UNITED STATES PATENT AND TRADEMARK OFFICE

APPLICATION NO.	FILING DATE	FIRST NAMED INVENTOR	ATTORNEY DOCKET NO.	CONFIRMATION NO.
10/606,479	06/26/2003	Robert J. Smith JR.	16930-1	5653
23486	7590	02/23/2004	EXAMINER	
SHUTTLEWORTH & INGERSOLL, P.L.C. 115 3RD STREET SE, SUITE 500 P.O. BOX 2107 CEDAR RAPIDS, IA 52406			MACARTHUR, VICTOR L	
			ART UNIT	PAPER NUMBER
			3679

Office Action Summary	Application No.	Applicant(s)
	10/606,479	SMITH ET AL.
	Examiner	Art Unit
	Victor MacArthur	3679

DETAILED ACTION

Marked up Fig.1

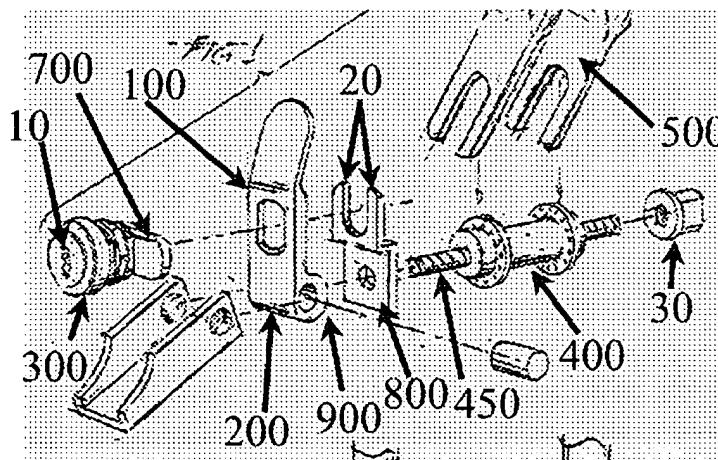
Claims 1-6, 8-13, 15, 16, 18, 19, 21 and 22 are rejected under 35 U.S.C. 102(b) as being anticipated by Katsouros US 2002/0026816 (Note that the drawings of the prior art do not contain reference numerals, therefore the reference numerals in the marked-up figures below do not correspond to those listed in the prior art detailed description of the drawings, but are merely used by the examiner to describe how the drawings disclose the applicant's claim limitations).

Claim 1. Katsouros discloses a locking quick release device for lockingly affixing a removable component (500) to a fixed component (100, 200 and 400 are fixed to wheel 600), the fixed component having a first member (100, 200) and a second member (400) moveable toward and away from each other between a first position (as seen in fig.2) in which the removable component is affixed to the fixed component and a second position (seen in fig.3) in which the removable component is removable from the fixed component, said locking quick release device comprising: a lever (100, 200) having a handle end (100) and a pivot end (200), the lever being

movable about the pivot end between an open position and a closed position so that movement of the lever to the closed position causes the members to move to the first position and movement of the lever to the open position causes the members to move to the second position; and a locking mechanism (300) operatively combined with the handle end of the lever to selectively prevent movement of the lever about its pivot end when the locking mechanism is actuated into a locked position.

Claim 2. Katsouros discloses that locking mechanism has a latching mechanism (700); and a receiving member (800) is combined with the fixed component for receiving the latching mechanism to provide for locking of the lever to the fixed component and thereby prevent removal of the removable component from the fixed component when the locking mechanism is actuated into a locked position.

Claim 3. Katsouros discloses that the receiving member is combined (in that 800 is attached to 100, 200) with the lever.

Claim 4. Katsouros discloses that the locking mechanism and lever are combined (via 400) with the removable component.

Claim 5. Katsouros discloses that the locking mechanism and lever are combined with the fixed component.

Claim 6. Katsouros discloses wherein the lever further comprises a cam surface (900) near the lever pivot end so that movement of the lever to the closed position moves the first and second members to the first position in which they are closer together, and movement of the lever to the open position moves the first and second members to the second position in which they are farther apart.

Claim 8. Katsouros discloses that the locking mechanism has a first end (near 700) and a second end (near 10) with a key slot (10) at the second end, said key slot being adapted to receive a key.

Claim 9. Katsouros discloses that the latching mechanism is turnable between a first and a second position when the key is inserted into and engaged within the key slot.

Claim 10. Katsouros discloses that the receiving member comprises a catch mechanism (20) that prevents the lever from moving to the open position when the latching mechanism is engaged in its second position and the lever is in the closed position.

Claim 11. Katsouros discloses that the catch mechanism is comprised of locking pins (elements 200 comprise locking pins within the broadest reasonable interpretation of the claim language).

Marked-up Fig.2

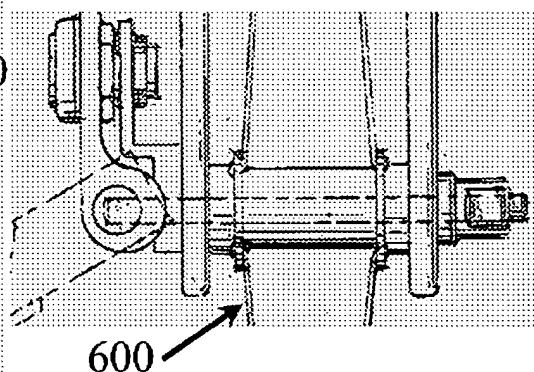
Claim 12. Katsouros discloses a bore (receiving 450) through both the first and the second members; and a threaded member (450) having a first end (right end of 450) and a second end (left end of 450) with threads on the first end, said threaded member second end combined with the lever near the lever pivot end, said threaded member passing through the bore with said threaded member first end being threaded into one of the members so that rotation of the lever causes the threaded member to move the first and second members closer together and farther apart.

Claim 13. Katsouros discloses a bore (receiving 450) through both the first and the second members; a threaded member (450) having a first end (right end of 450) and a second end (left end of 450) with threads on the first end, said threaded member second end combined with the lever near the lever pivot end, said threaded member passing through the bore; and a thumb

screw (30) threaded onto the threaded member first end, said thumb screw capable of moving the first and second members closer together and farther apart when the thumb screw is moved relative to the threaded member.

Claim 18. Katsouros discloses a method for locking and unlocking a removable component to a bicycle frame wherein the removable component (400, 450) is positioned between two holding members (500) tightened by a movable lever (100) that includes a locking mechanism (300) that is engaged with a receiving member (20), said method comprising: inserting the removable component (400, 450) between the holding members; tightening the removable component between the holding members by moving the lever (100); moving the lever to a closed position (as seen in fig.2) wherein a portion of the locking mechanism becomes engaged with the receiving member; and operating the locking mechanism so that the lever is locked in the closed position.

Claim 19. Katsouros discloses that the locking mechanism includes a key slot (10) adapted to receive a key.

Claim 21. Katsouros discloses that the lever includes a cam surface (900) so that as the lever is moved toward the receiving member, the holding members are drawn closer together to further tighten the removable component in between the holding members.

Claim 22. Claim Katsouros discloses that the lever comprises the locking mechanism (300).
